*Second Preliminary Consultation*  
**MONTGOMERY COUNTY HISTORIC PRESERVATION COMMISSION**  
**STAFF REPORT**

<b>Address:</b>	10701 Keswick St., Garrett Park	<b>Meeting Date:</b>	1/21/2026
<b>Resource:</b>	Master Plan Site #30/13-1 <b>Truitt-Richter House</b>	<b>Report Date:</b>	1/14/2026
<b>Applicant:</b>	Dan Andrews	<b>Public Notice:</b>	1/7/2026
<b>Review:</b>	Preliminary Consultation	<b>Staff:</b>	Dan Bruechert
<b>Proposal:</b>	Construction of Infill Single Family House and Detached Garage, With Associated Grading, Site Alterations, and Tree Removals

**Historic Preservation Commission Preliminary Consultation Report**

Figure 2: The Truitt-Richter property showing the environmental setting in red (left) and the proposed site plan (right).

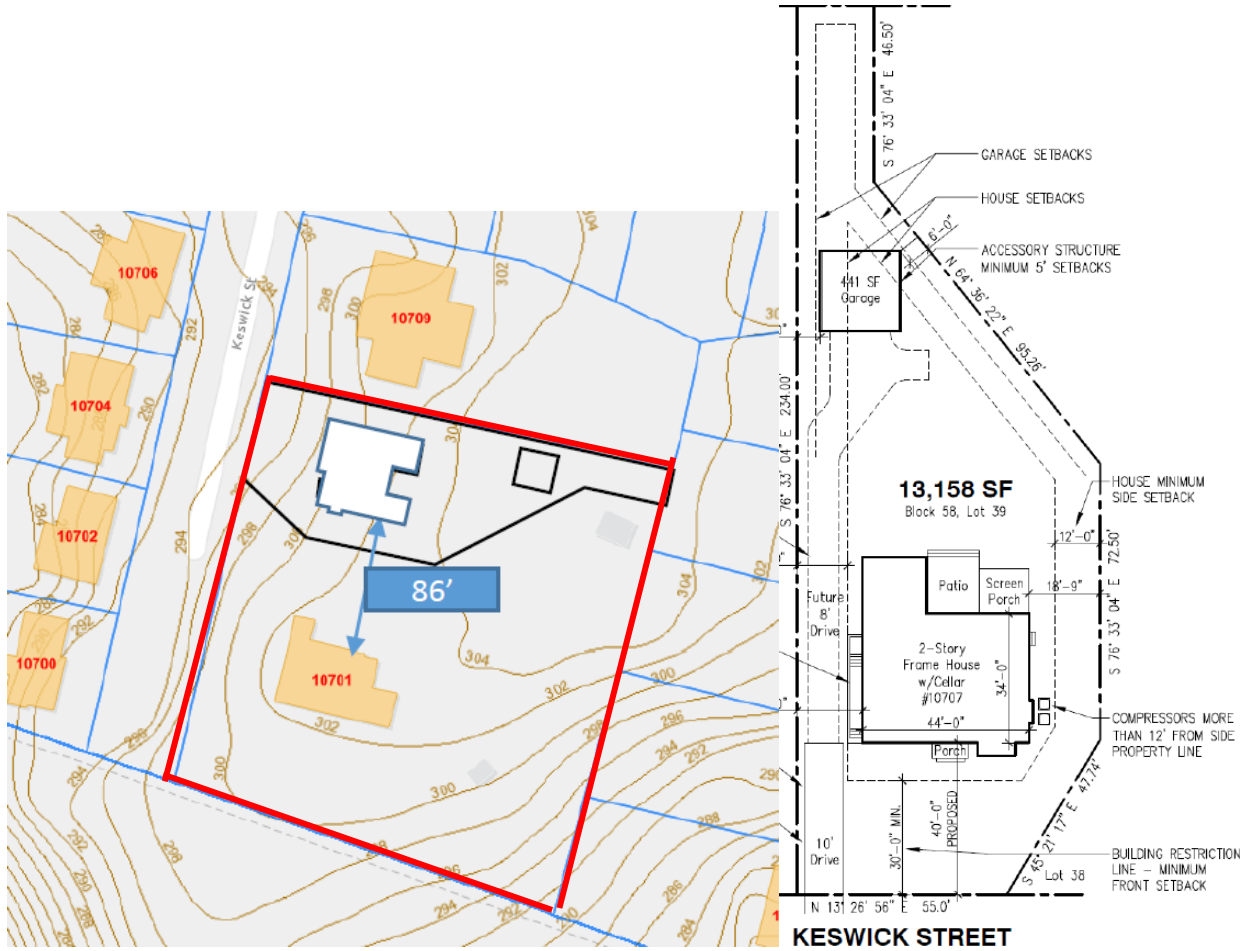
The proposed house location is 86’ (eighty-six feet) to the north of the Truitt-Richter House, matching its approximate setback on the lot. A house location on the subject property is limited by the buildable envelope created by the size and shape of the subject lot (see *Figure 2*, above).

Staff finds the location of the proposed house is appropriate under 24A-8(b)(2) and *Standard #2* and was considered by the HPC in the April 2025 HAWP approving the lot subdivision. Commissioners were supportive of the house placement and the distance separating the two houses at the December 2025 Preliminary Consultation.

Figure 3: December 2025 submission (left) and revised design (right).

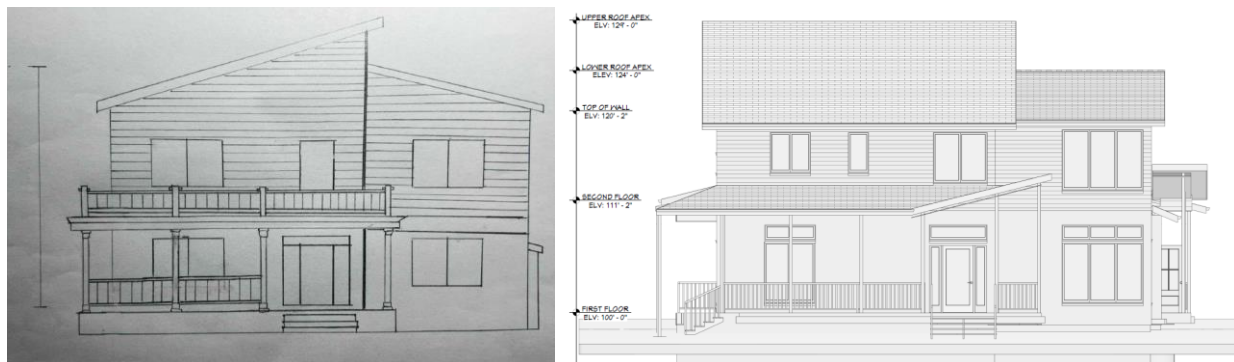
The proposed house is constructed as two volumes. The larger left volume is 27' 6" (twenty-seven feet, six inches) wide and has a wrap around porch that extends 6' (six feet) to the north (left) of the house. The wrap around porch includes a shed roof section over the primary entrance. Staff notes the detailing on the porch has been simplified, a treatment that was recommended by a couple of commissioners at the December 2025 Preliminary Consultation. This section of the house has a shed roof with a maximum height of 29' (twenty-nine feet), that that slopes towards the street.

The right volume is 15' 6" (fifteen feet, six inches) wide and has a lower side gable roof with a 24' (twenty-four foot) ridge height. This section of the house has stacked window assemblies.

Staff next evaluated the massing of the proposed building. The proposed front elevation is one foot wider than the historic house (without the porch extensions or porte-cochere) and its roof height is approximately ten feet lower. The lower house section on the right also helps to shift more mass away from the Truitt-Richter House. Staff finds the change to a side shed and gable roof forms helps to shift some the proposed house's apparent mass away from the front wall plane. The eave at the front of the house has now been lowered so it is just above the second story windows, instead of even with the ceiling height. While the changes to the roof form are a positive step in reducing the apparent mass of the house, Staff continues to find that the house was too wide at the front to satisfy the requirements of *Standard #9*.

Figure 4: Contemporary house design, only 34' 6" wide and nearly 3,400 ft<sup>2</sup>.

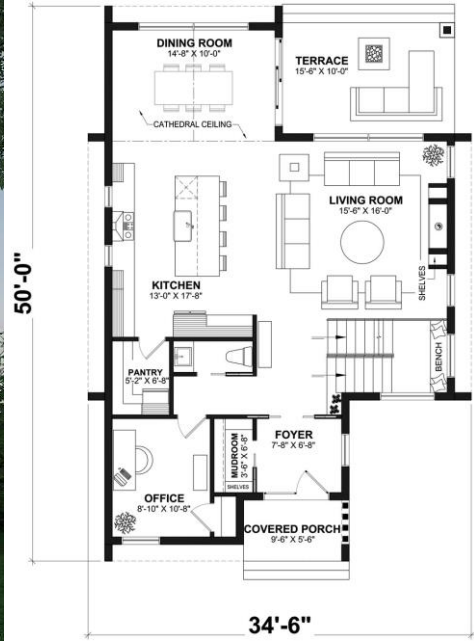
In its background research for this development proposal, Staff identified several examples of house plans that would generally satisfy the square footage desired by the applicant and the narrower width determined to be critically important by Staff. These designs are not intended to be prescriptive, rather their purpose is to show architectural elements that may help achieve some of the criteria necessary for a project that satisfies the requirements of Chapter 24A and the *Standards*.
